STAFF ANALYSIS

CASE NO.:	Z-26-1247833	File ID #: 2025-1621
Address:	8277 Norris Lake Way Snellville, GA 30039	Commission District: 5 Super District: 7
Parcel ID(s):	16-228-01-007	
Request:	Rezone property from the R-85 (Residential Medium Lot-85) Zoning District to the RNC (Residential Neighborhood Conservation) Zoning District for the development of up to 214 single-family detached dwellings, which will be Phases 3 and 4 of the adjacent Champions Run Subdivision.	
Property Owner(s):	D.R. Horton, Inc.	
Applicant/Agent:	D.R. Horton c/o Battle Law, P.C.	
Acreage:	113.78 acres	
Existing Land Use:	Vacant	
Adjacent Zoning:	North: R-85 East: R-85 (across Norris Lake Drive) South: RNC West: MZ	
Comprehensive Plan:	Suburban (SUB) <u> X </u> Consistent _____ Inconsistent

STAFF RECOMMENDATION: TWO-CYCLE DEFERRAL

COVER SHEET
FOR
CREEKSIDE VILLAGE
DRI #4478
LOCATED IN:
LAND LOTS 188, 189, 196, 197 16th DISTRICT
DEKALB COUNTY, GEORGIA

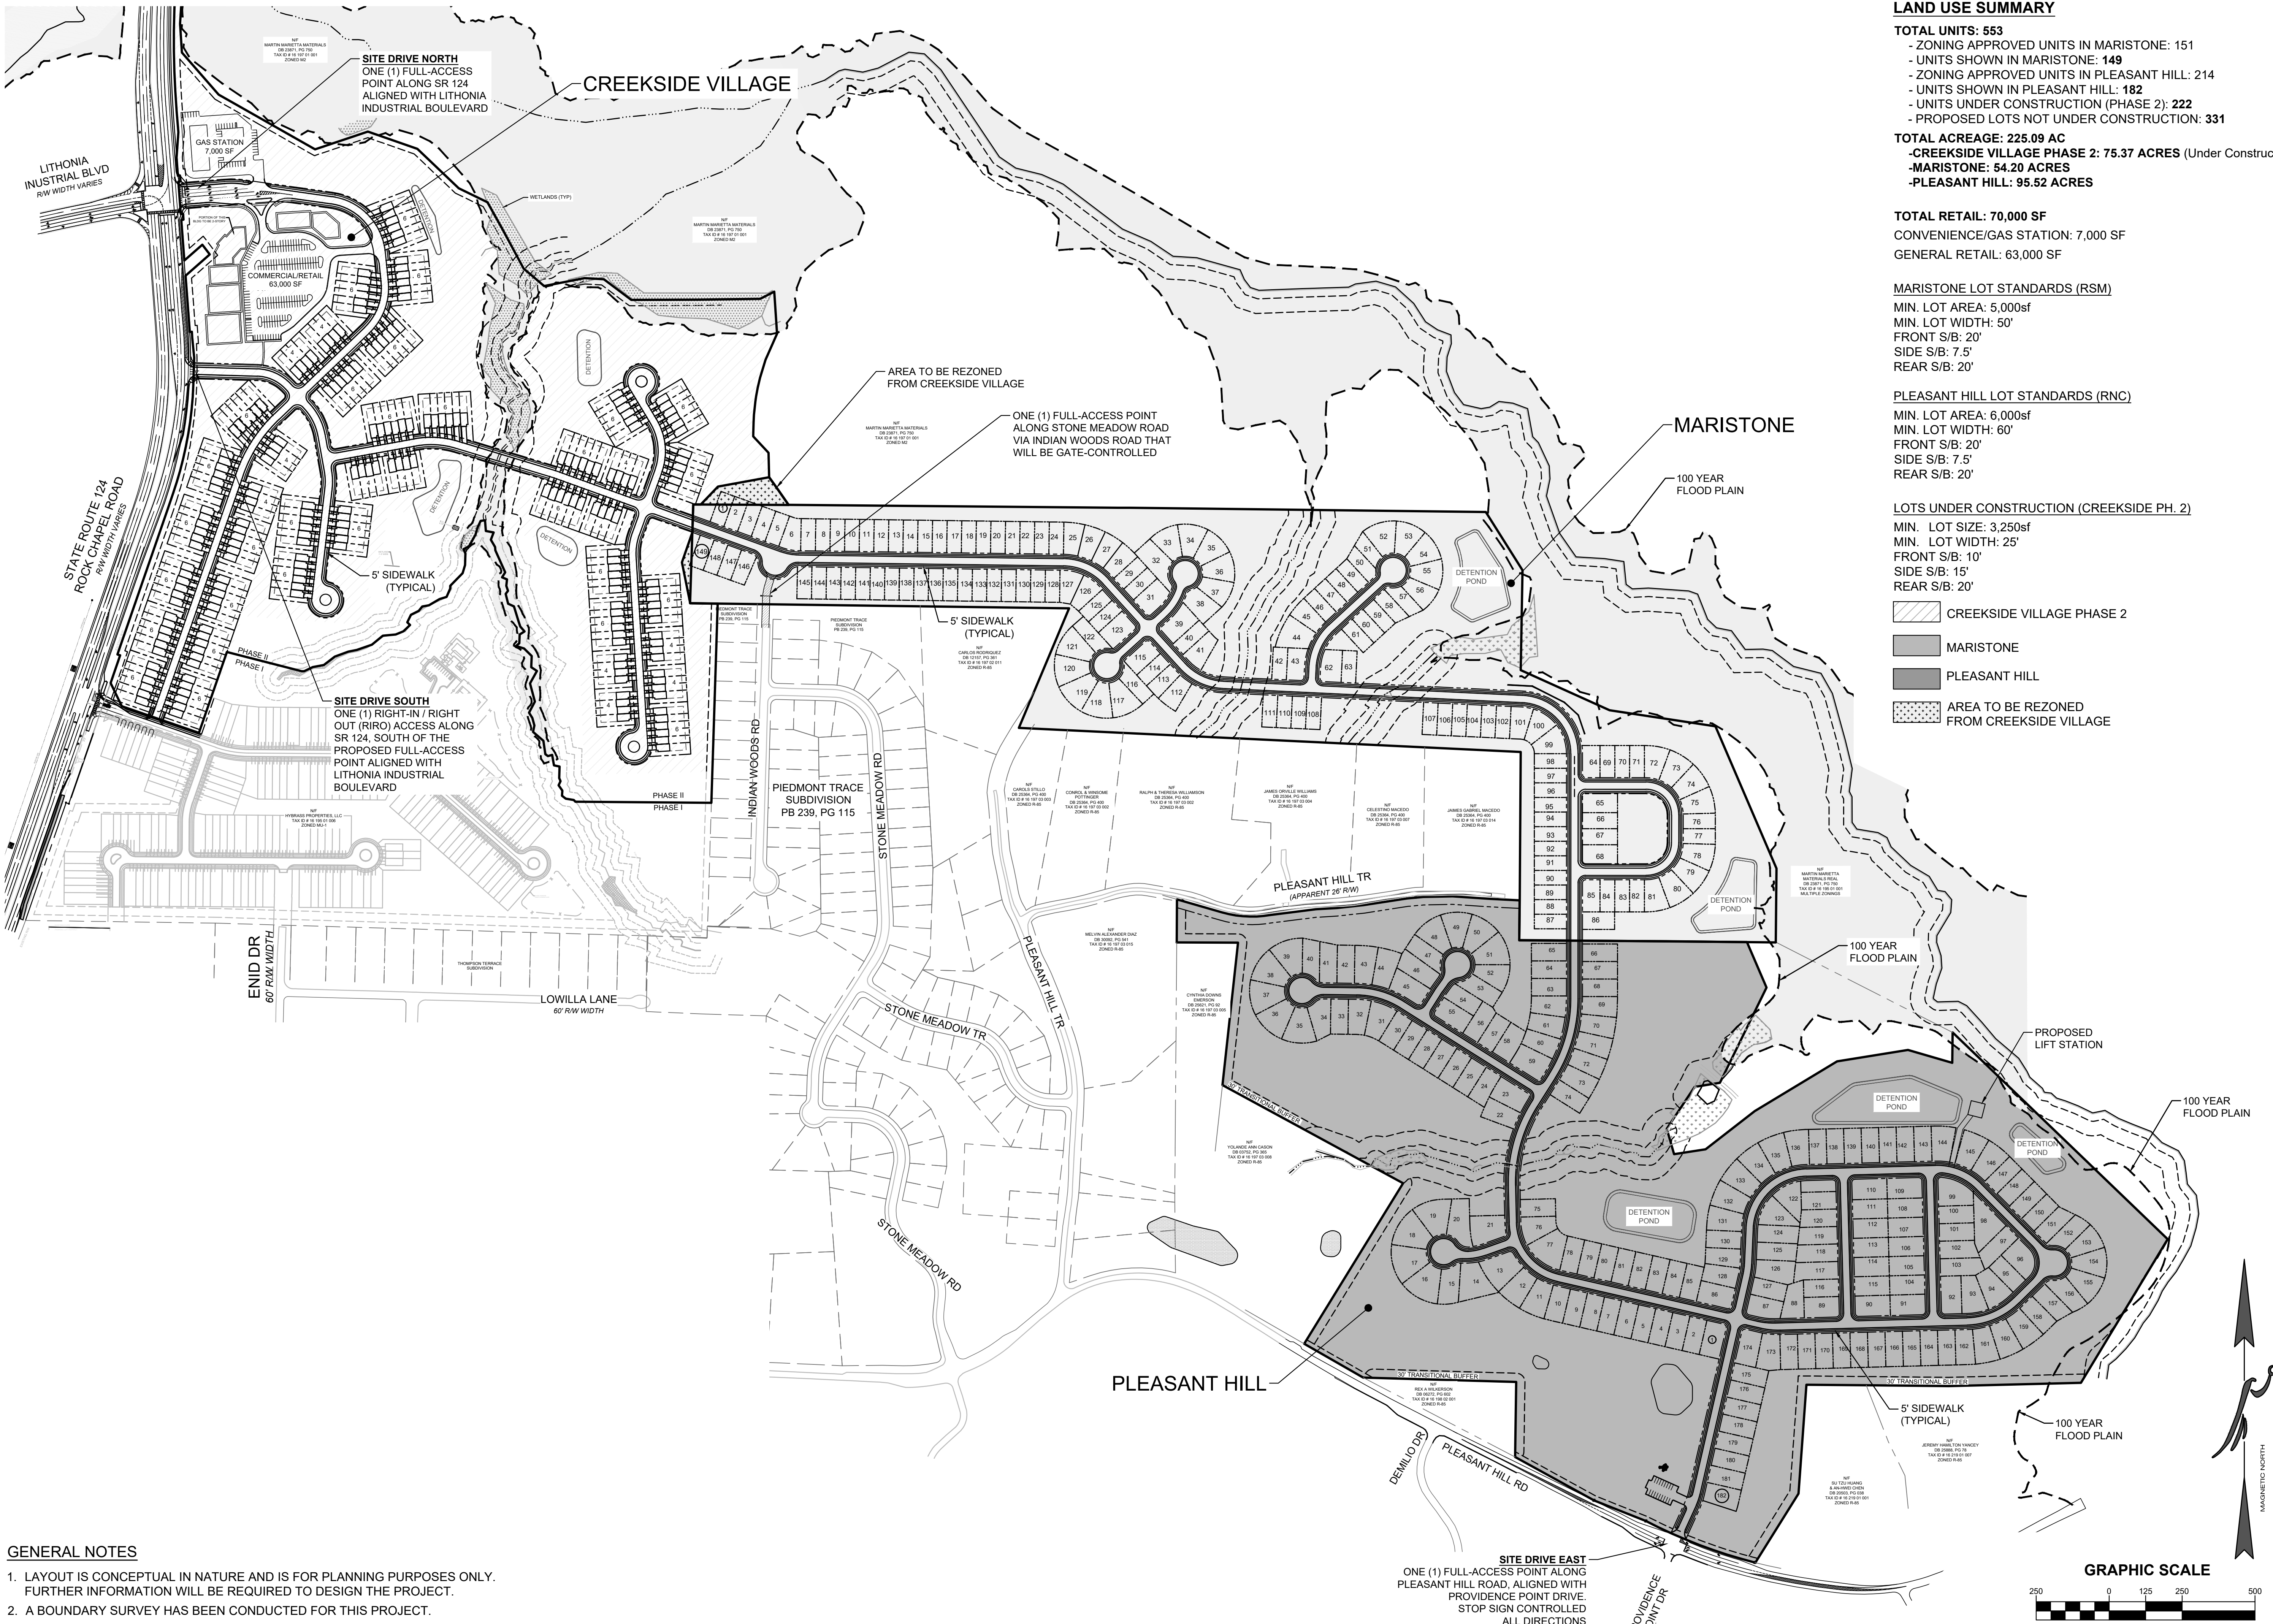
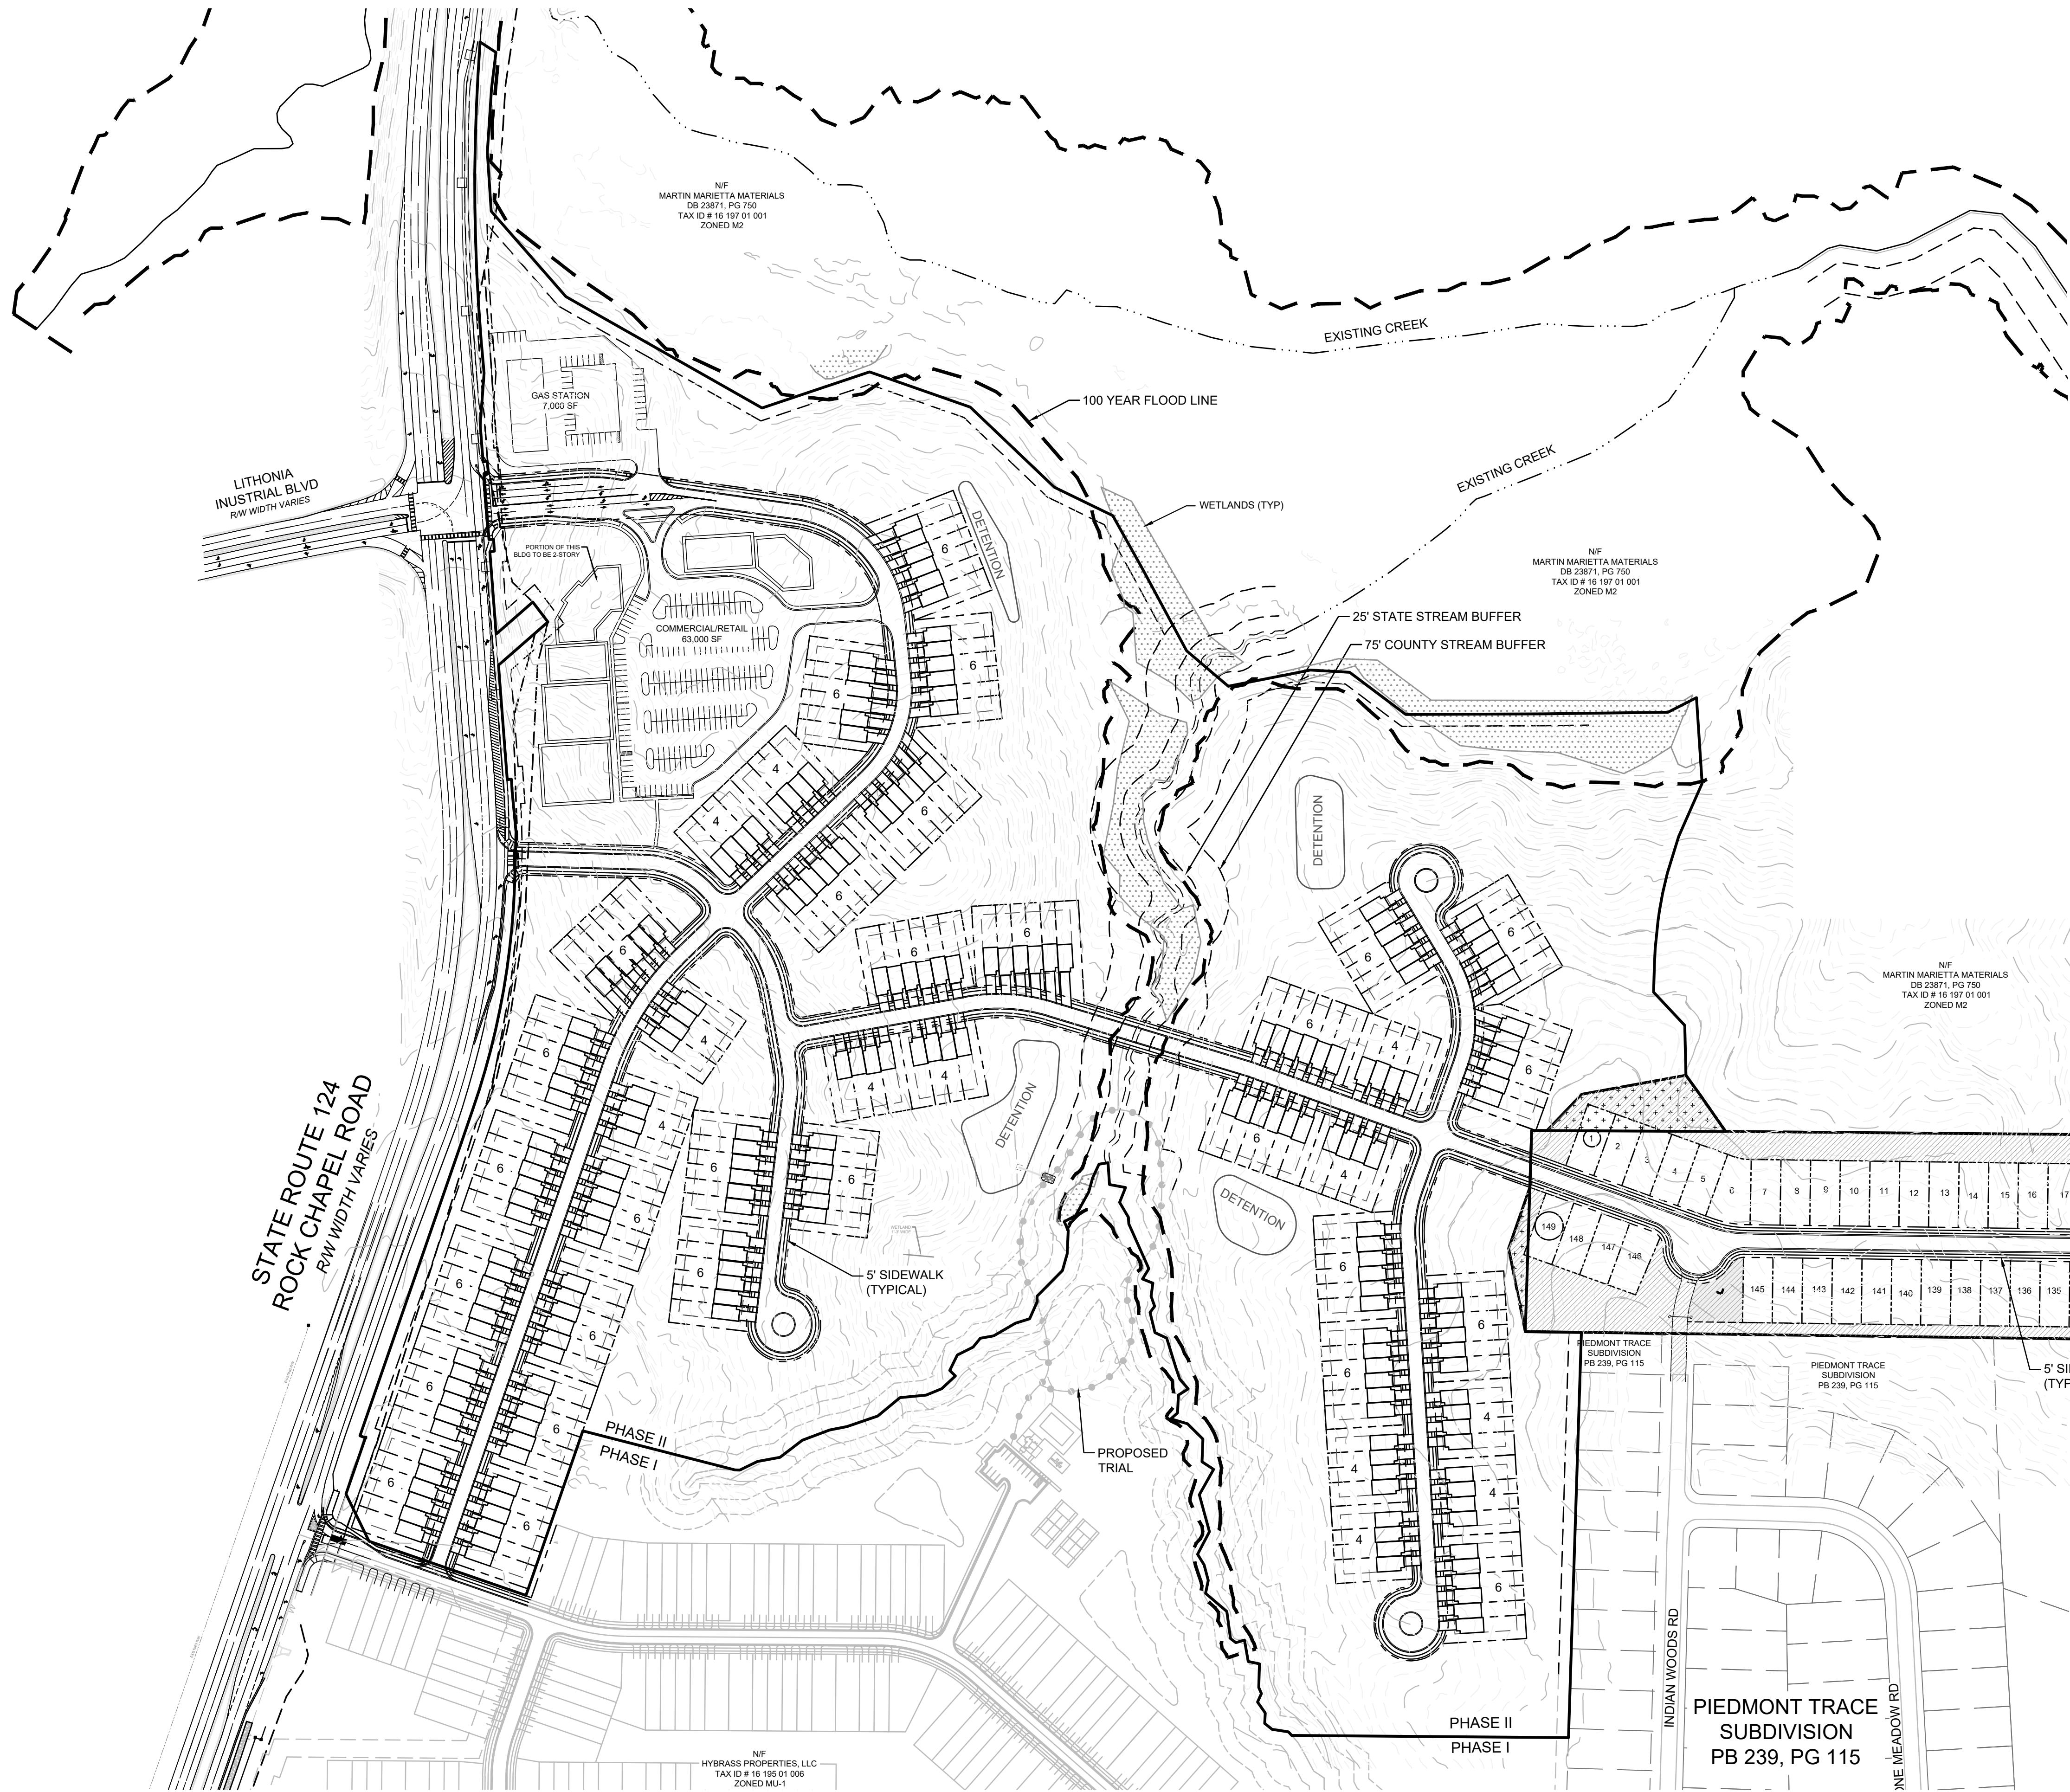
The floodplain on the tributary closest to Rock Chapel Road is identified as 100-year floodplain on the site plan but is shown as 500-year floodplain on the FEMA coverage. The floodplain along the tributary should be corrected and any Swift Creek 500-year floodplain on the property should be shown and identified.
